66105A-08

S E R V I C E N O T E

66105A DC Power Supply

The instrument will not communicate or will not complete self test.

Diagram A: ROM not fully inserted

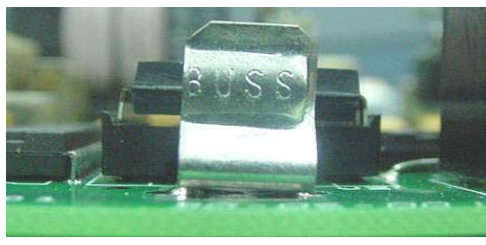
The Programmed ROM P/N 5080-2529 (Circuit Reference “U2”) See [Figure 1](#).below for the location of “U2”. When the ROM “U2” is not inserted correctly See [Diagram “A”](#) for details, the instrument may exhibit the following faults:

These faults could also occur if the ROM or the socket is intermittent due to dirty or contaminated pins.

1. The instrument will not turn on
2. All of the segments on the Front Panel display are not light.
3. The instrument will fail self test or will not boot-up.
4. The instrument will not communicate & can not be calibrated.

The ROM “U2” should be removed from the socket. (See [Figure 1](#)). The socket and the ROM should be inspected for contamination or other defects. The ROM is a ceramic part and can be damaged or broken if too much force is applied when reinstalled. [Diagram “B”](#) shows the ROM “U2” inserted correctly.
